ATTACHMENT C-1

MARKED UP PAGES FOR
PROPOSED CHANGES TO APPENDIX A
TECHNICAL SPECIFICATIONS OF
FACILITY OPERATING LICENSES
NPF-72, AND NPF-77

BRAIDWOOD STATION UNITS 1 & 2
REVISED PAGES:

ATTACHMENT C-2

FIGURE 3.4-1

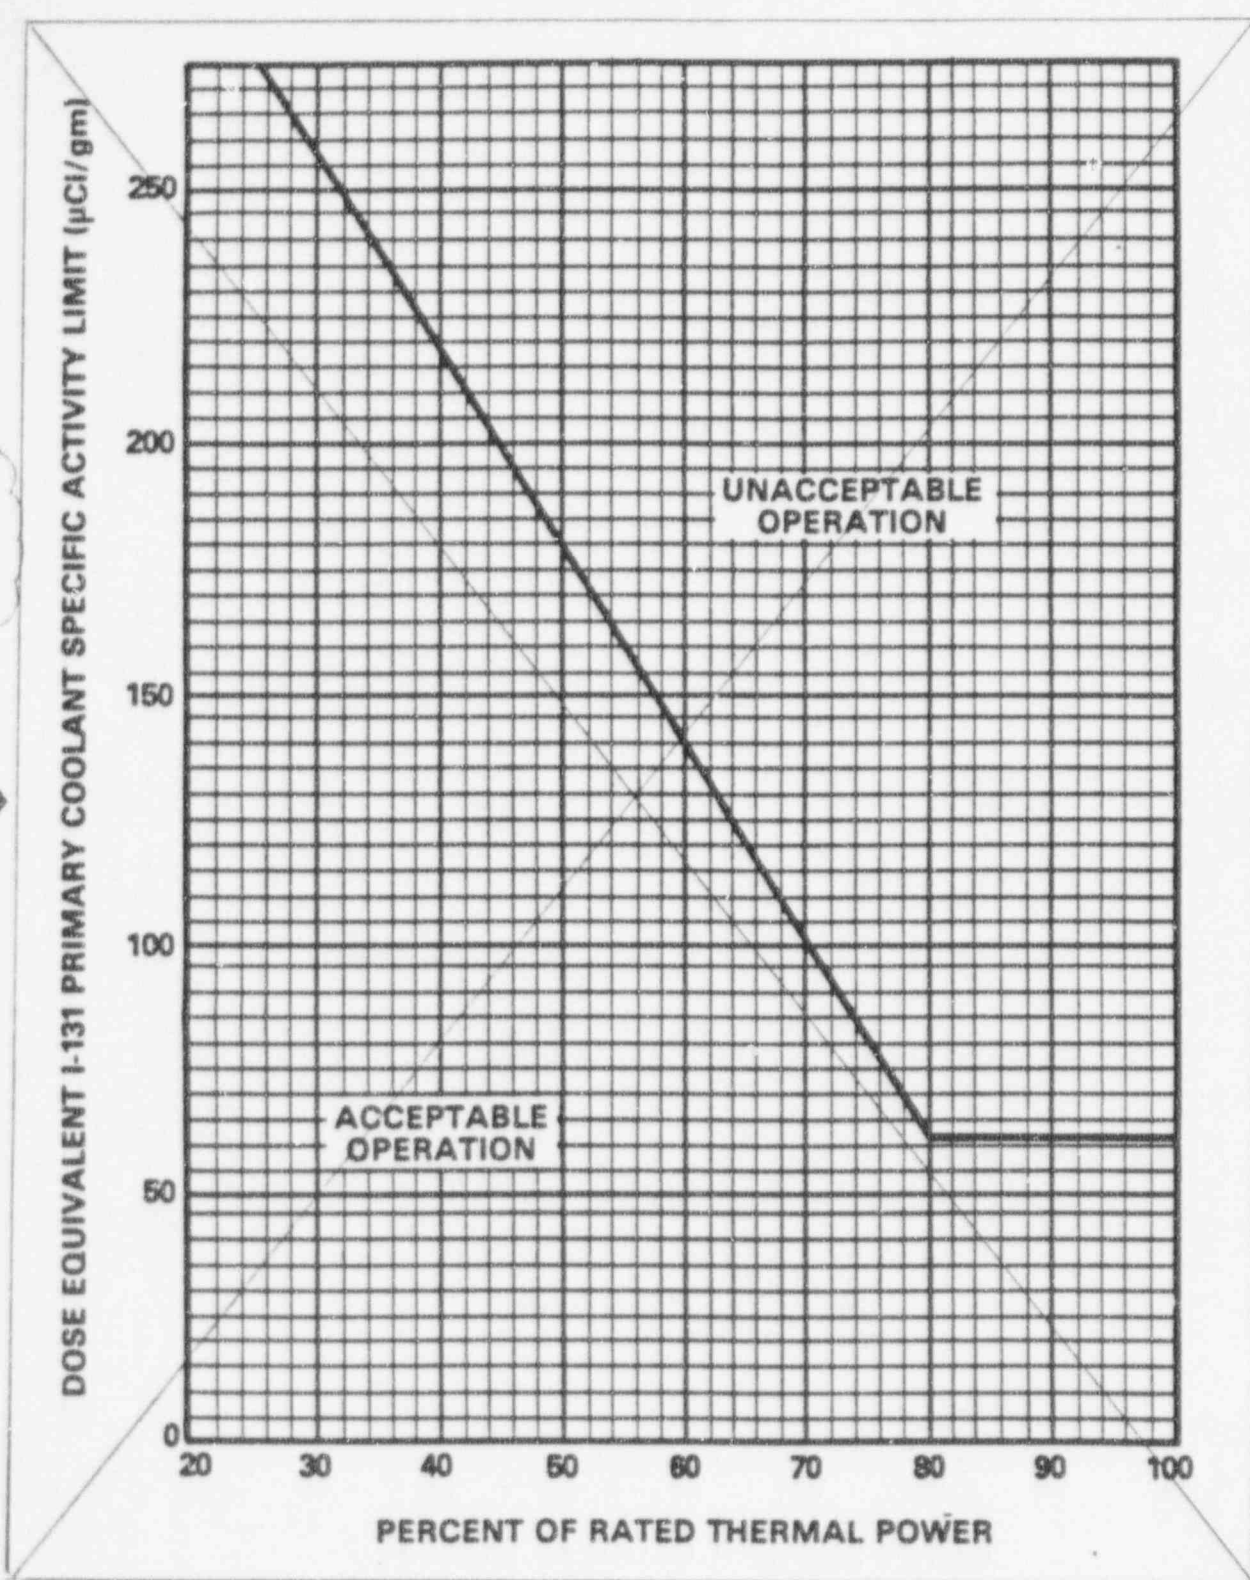
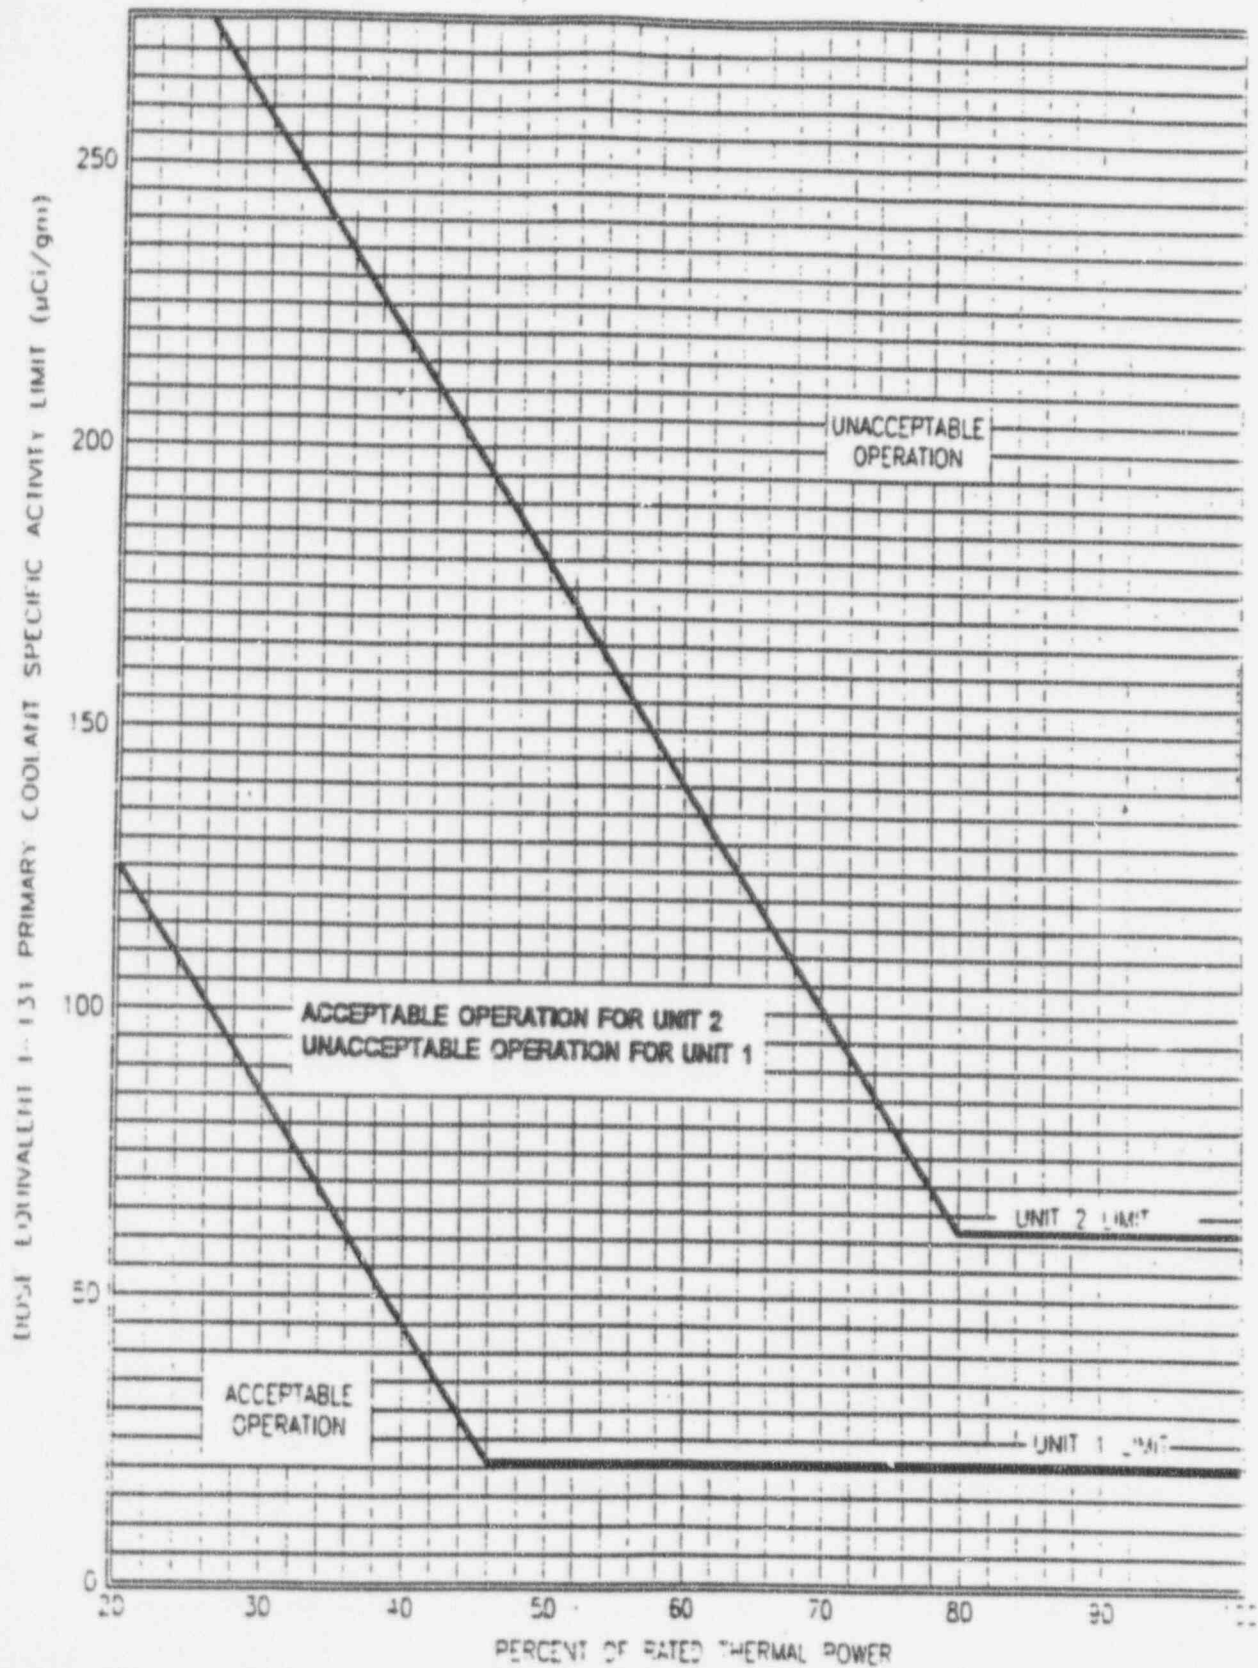
* For Unit 1, Reactor Coolant Specific Activity > 0.35 μCi/Gram
Dose Equivalent I-131

Byron and Braidwood will be adding footnotes to TS 3.4.8 and revising Figure 3.4-1 to reduce the Unit 1 dose equivalent I-131 limit from 1.0 microCurie per gram ($\mu\text{Ci/gm}$) to 0.35 $\mu\text{Ci/gm}$.

INSERT F

(Figure 3.4-1)

Figure 3.4-1 Dose Equivalent I-131 Reactor Coolant Specific Activity Limit Versus Percent of Rated Thermal Power with the Reactor Coolant Specific Activity $> 1\mu\text{Ci}/\text{Gram}$ Dose Equivalent I-131*

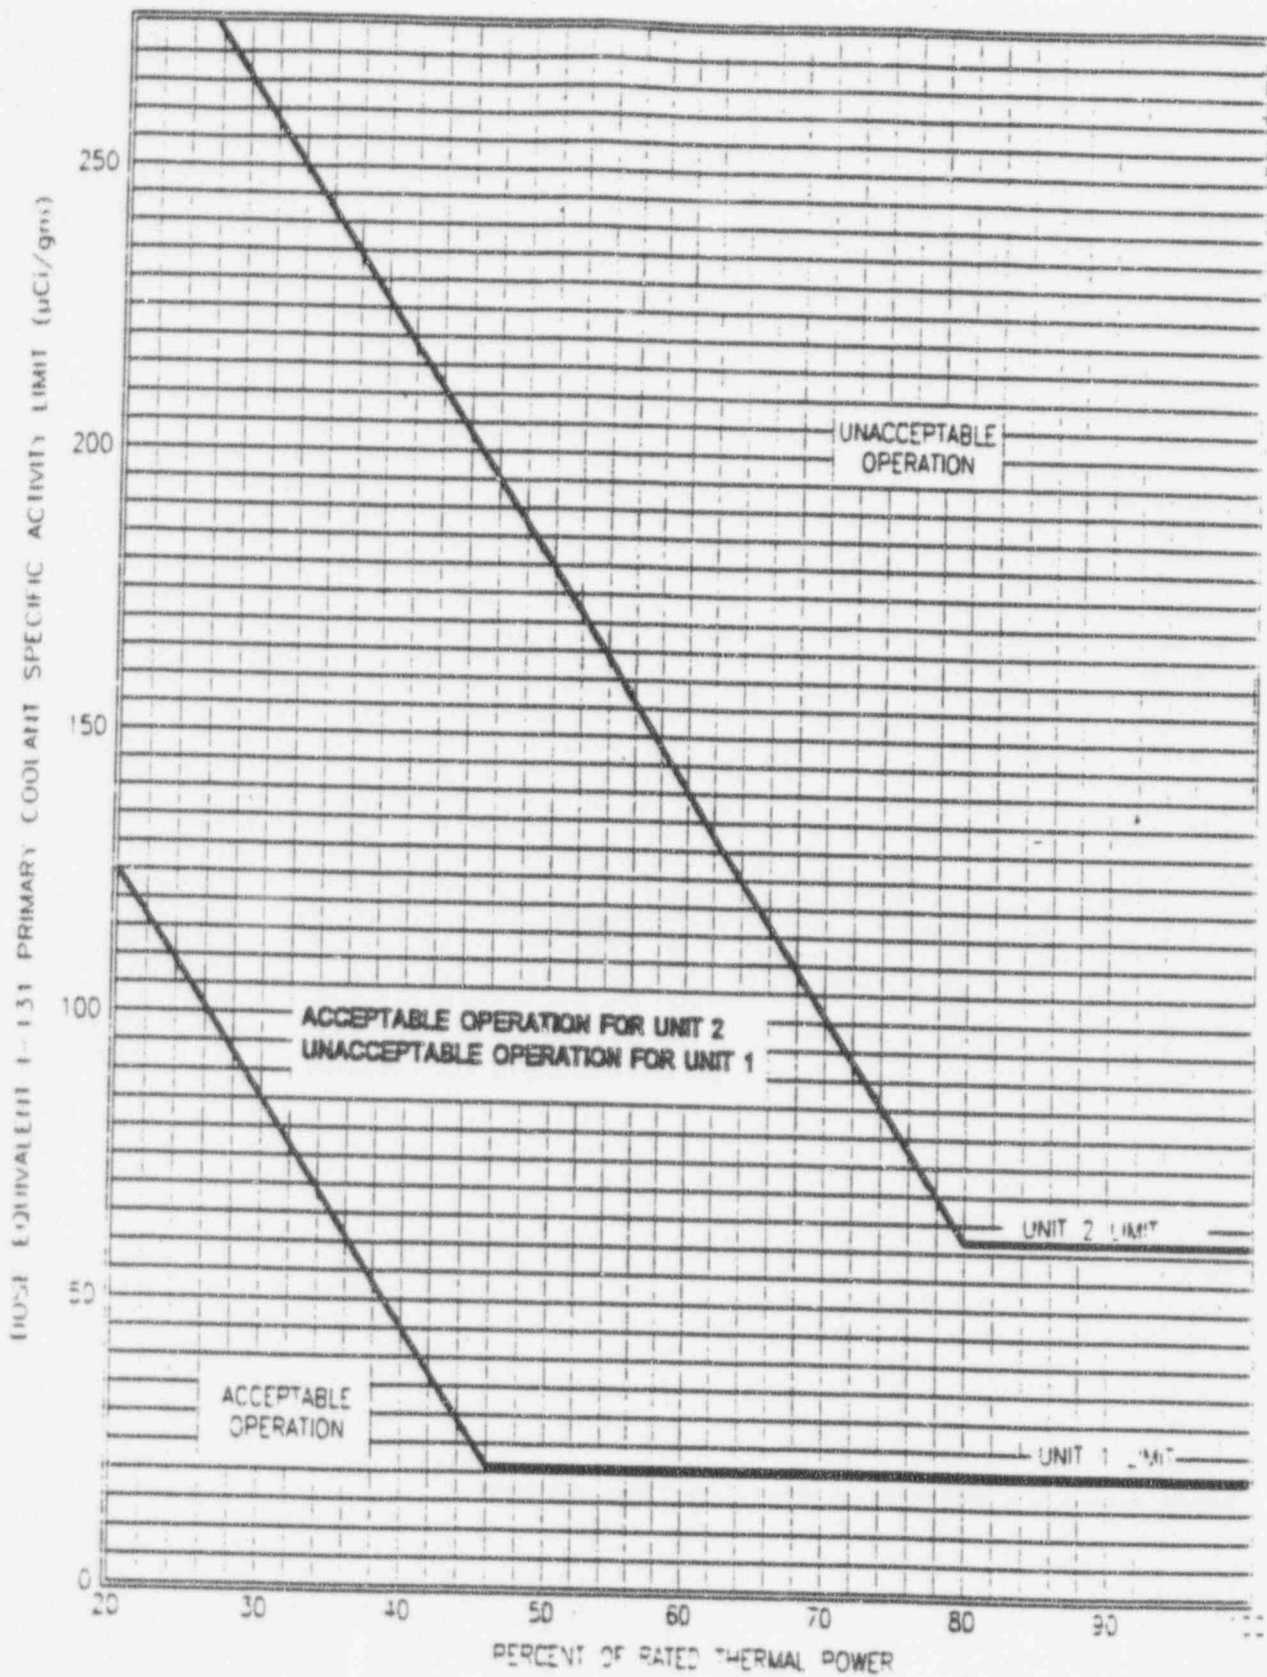
Replace
with
insert F

INSERT F

(Figure 3.4-1)
